MIL-B-46506D
 AMENDMENT 6
 04 January 1994
 SUPERSEDING
 AMENDMENT 5
 18 March 1991

MILITARY SPECIFICATION
 BOXES, AMMUNITION PACKING,
 WOOD, WIREBOUND

This amendment forms a part of Military Specification MIL-B-46506D, dated 30 August 1984, and is approved for use by all the Departments and Agencies of the Department of Defense.

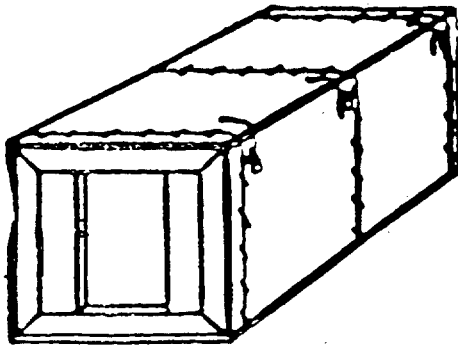
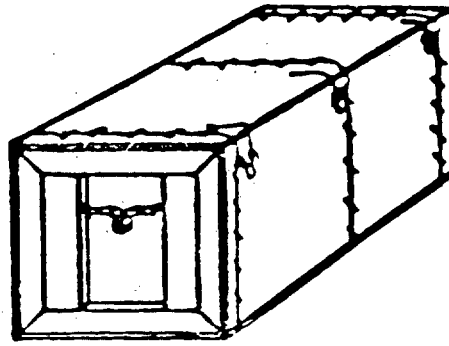
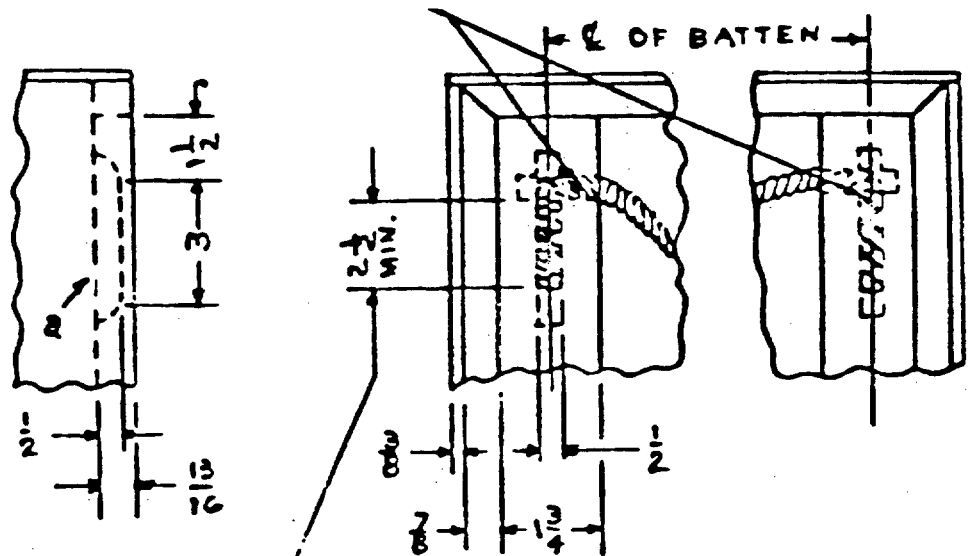
Figure 1: Delete in its entirety and substitute the included Figure 1.

FIGURE 1A.
9(24)

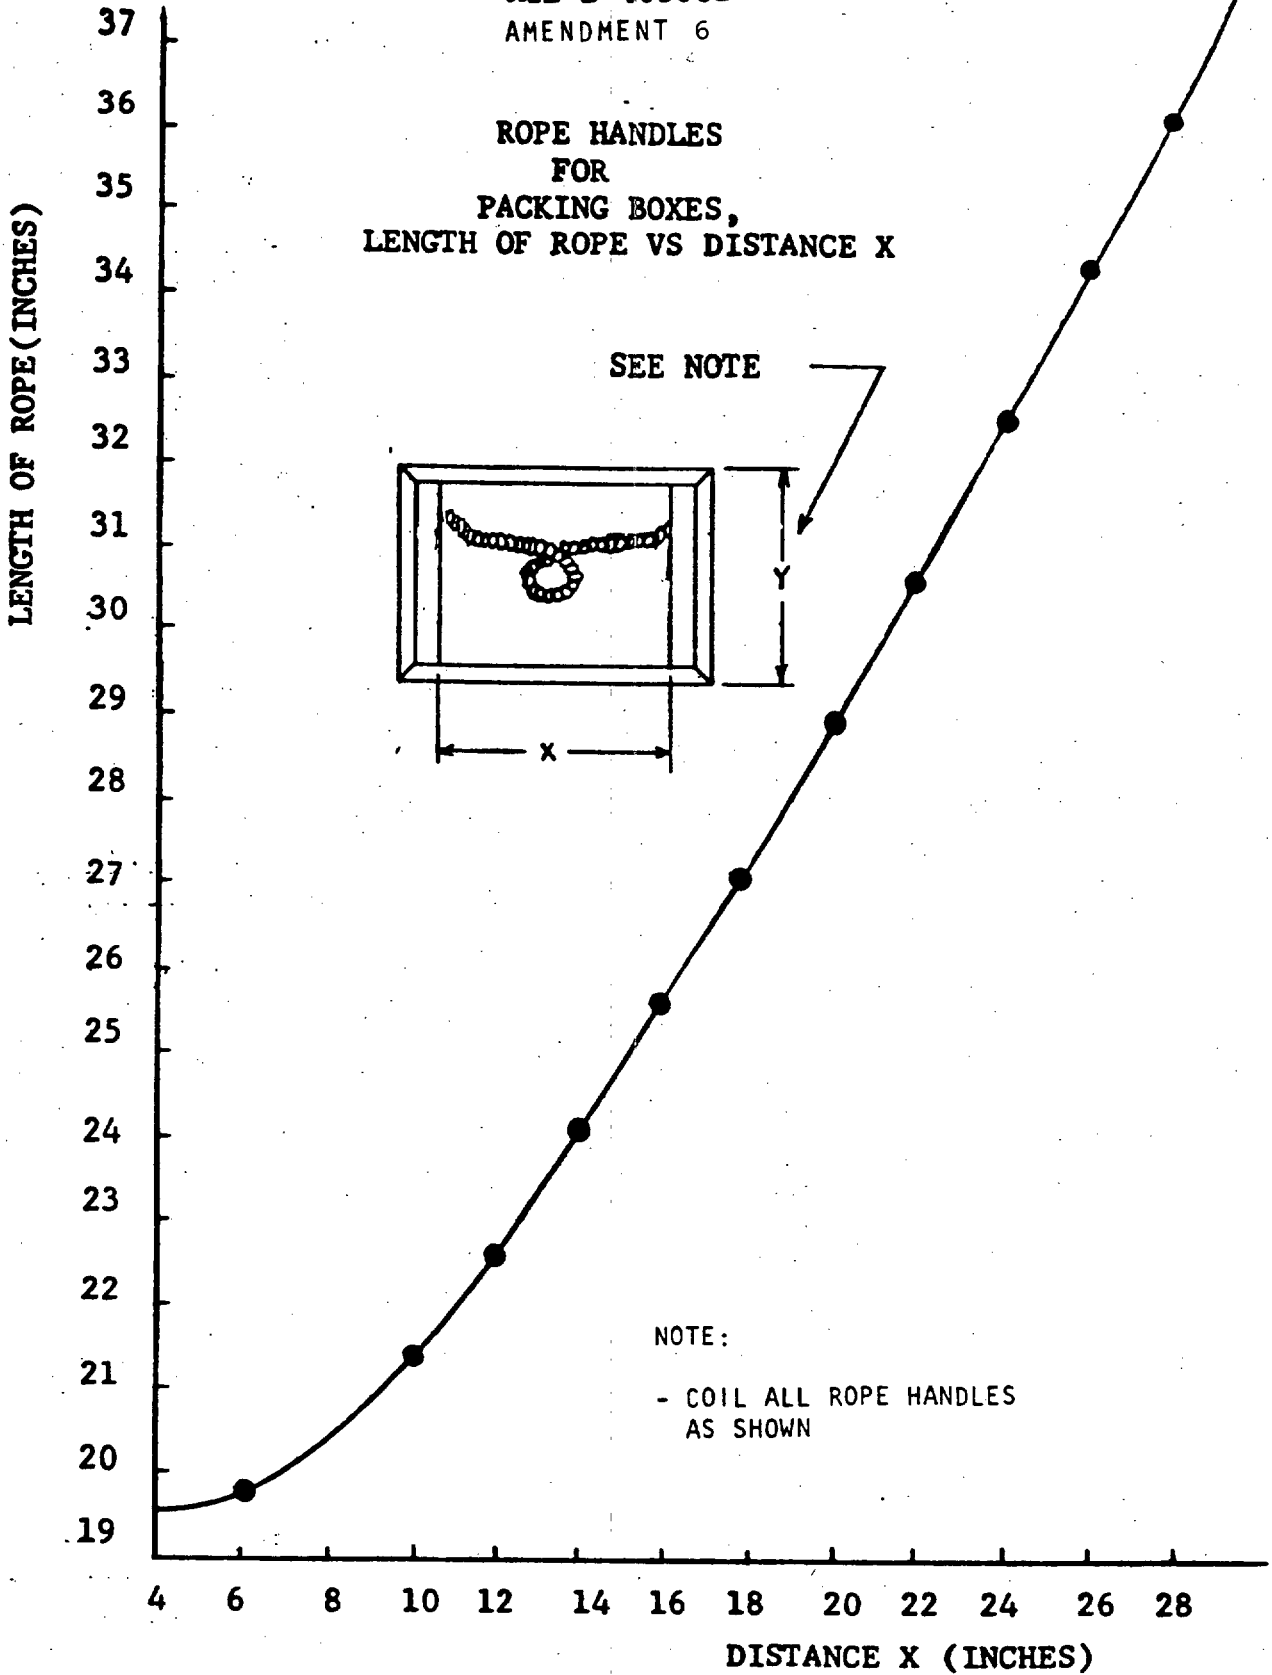
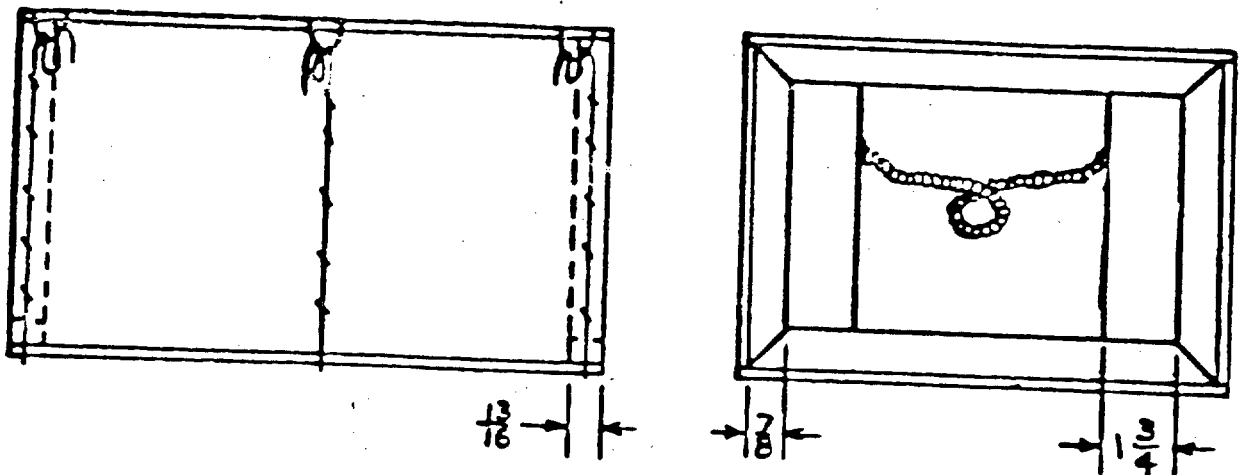
- * After last sentence, add: "This length includes approximately six inches of rope (three inches under each cleat) that is routed under the cleats for attachment of the rope handle."

Figure 1A. Delete in its entirety and substitute the included figure 1A.
